KANATA NORTH URBAN
EXPANSION AREA

To / Destinataire	Wendy Tse	File/N° de fichier:
From / Expéditeur	Ted Cooper, P. Eng. Darlene Conway, P. Eng.	
Subject / Objet	Additional Comments: Kanata North Community Design Plan EMP and MSS Final Drafts (Novatech, April 4, 2016)	Date: May 10, 2016

**Reference: Kanata North CDP - EMP and MSS Final Drafts – Additional Comments
Response to Comments
Our File No. 112117**

FIGURE NO. 9.2

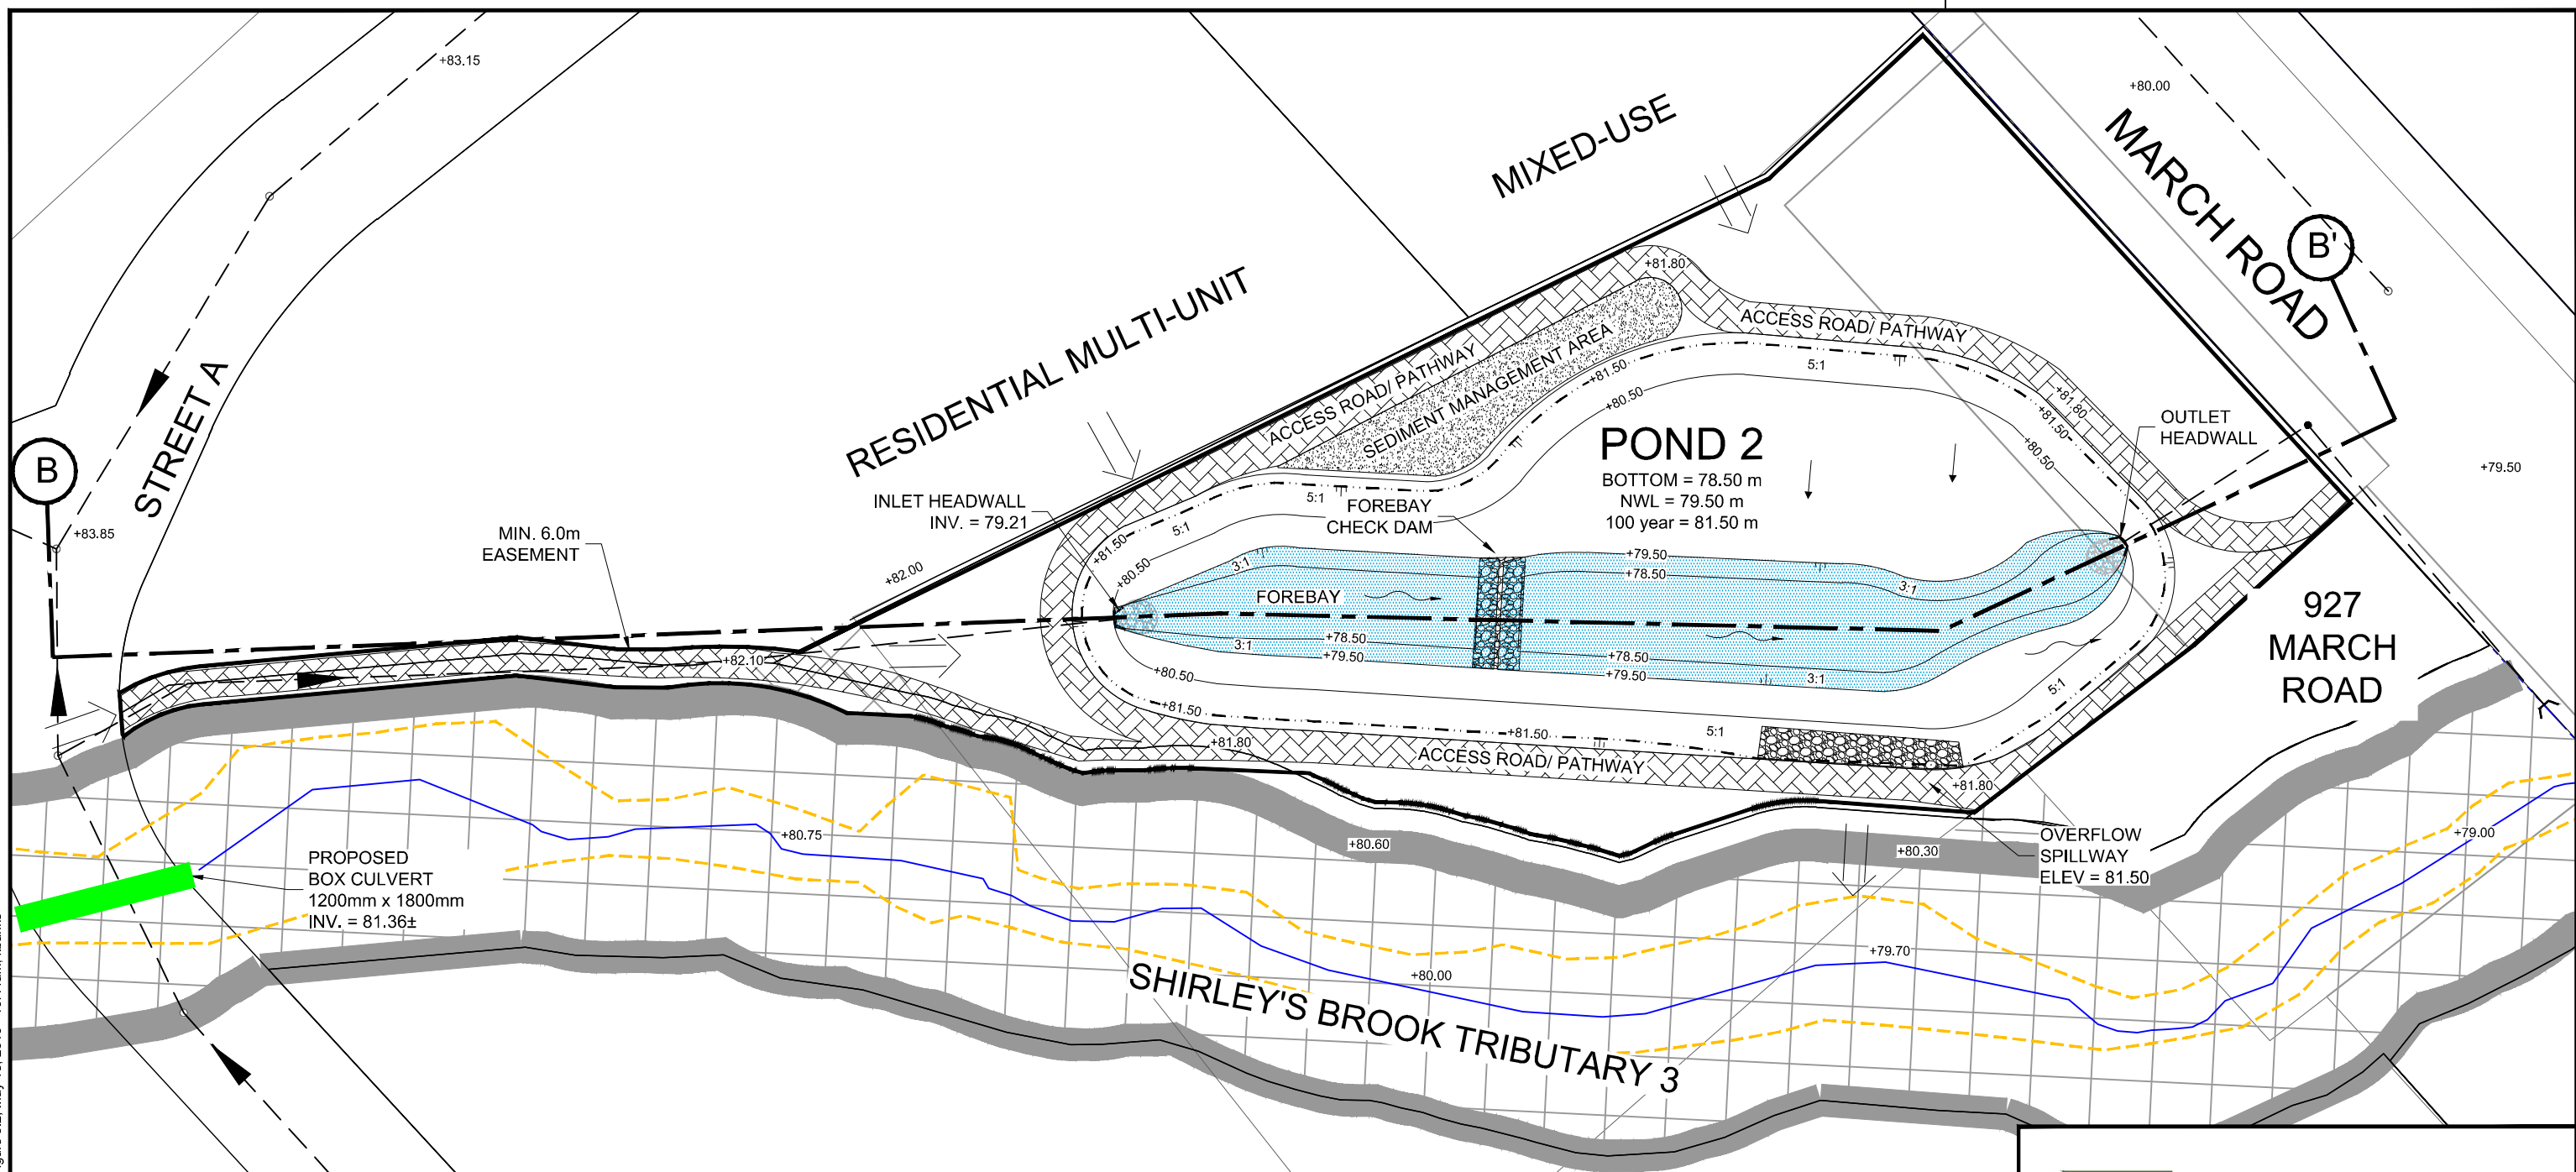
- a) The SWM Block must be expanded to include the land required for the major and minor system outlets/maintenance access to the pond; provide conceptual details/grading for major and minor system inlets/outlets to pond to confirm required block requirements.

- b) Per the Preliminary Grading Plan, please demonstrate how major system flows are to be conveyed to Pond 2 through the Residential Multi-unit and the Mixed use blocks and identify any land requirements for this purpose.

- The overland flow route to Pond 2 will follow the proposed pathway/ access road adjacent to Tributary 3, as shown on revised Figure 9.2. The 6.0m wide pathway block will provide the required capacity to convey the overland flows from Street A to Pond 2 – supporting calculations will be provided in the MSS.

- Major system flows from upstream areas will not be conveyed through the Residential Multi-unit and Mixed Use blocks. Any overland flow from these blocks will be directed to Pond 2, but major overland flows from the surrounding areas will be confined to the right-of-ways and/or the defined overland flow routes shown on the Preliminary Grading Plan.

FIGURE NO. 9.3
POND 2A
CONCEPTUAL LAYOUT

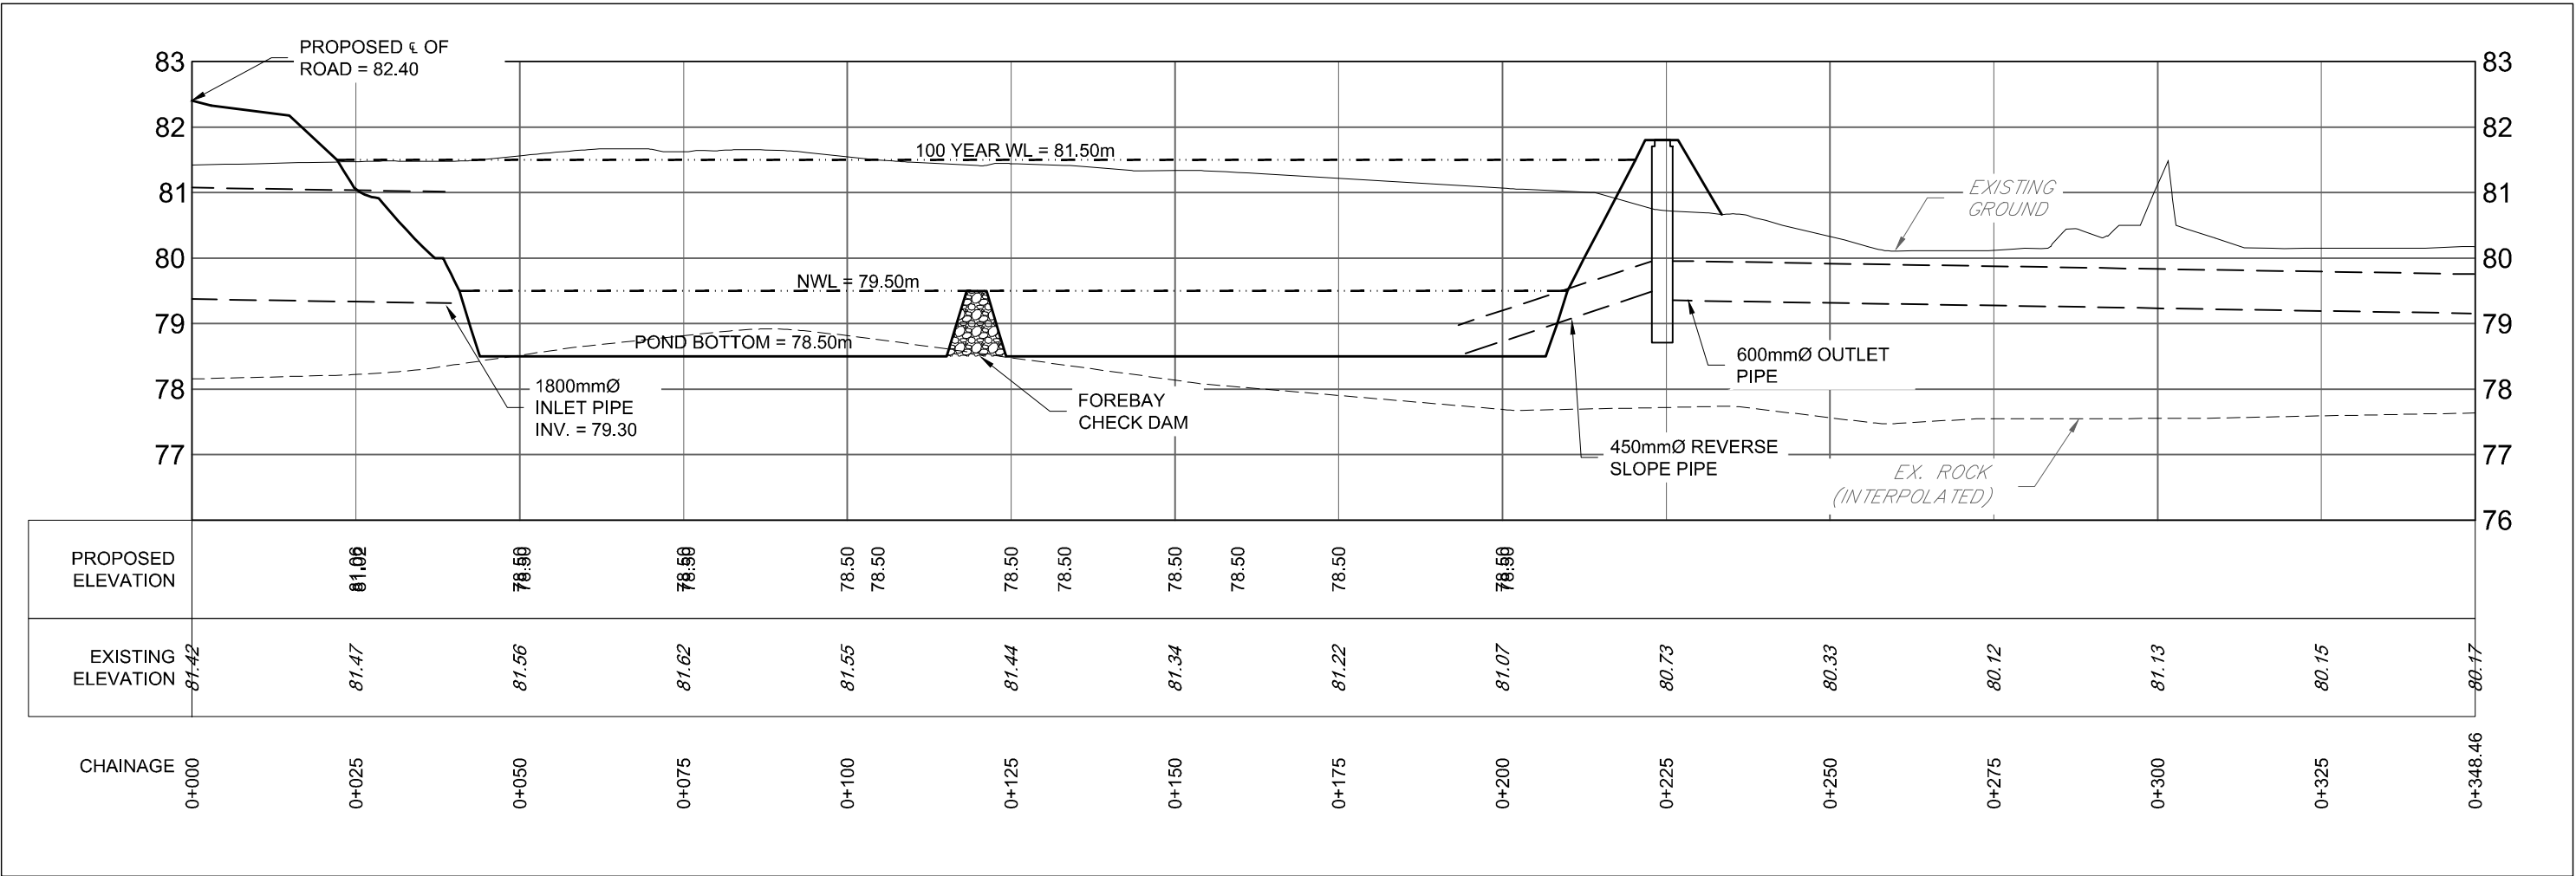
- b) The direction of major system flow at March Road and the Collector Road illustrated on Figure 9.3 is inconsistent with Plan and Profile drawing PP3. Please clarify and/or revise as required.

- The proposed road grades shown on the grading plans provided as a part of the MSS have not been designed taking Pond 2A into consideration as Pond 2A is only intended as an alternative pond location within the Southwest Quadrant of the site.

Notwithstanding the above, the grading design for Street A could easily be adjusted to provide a low point and route major system flows into Pond 2A.

- As stated above, the proposed road grades have not been developed with Pond 2A in mind as it is intended as an alternative pond location. If Pond 2A is selected as the final location for the SWM facility, the proposed road grading will be adjusted as required.
- While not consistent with the Plan and Profile Drawing, Figure 9.3 has been revised to reflect the anticipated major drainage flow routes associated with this alternative.
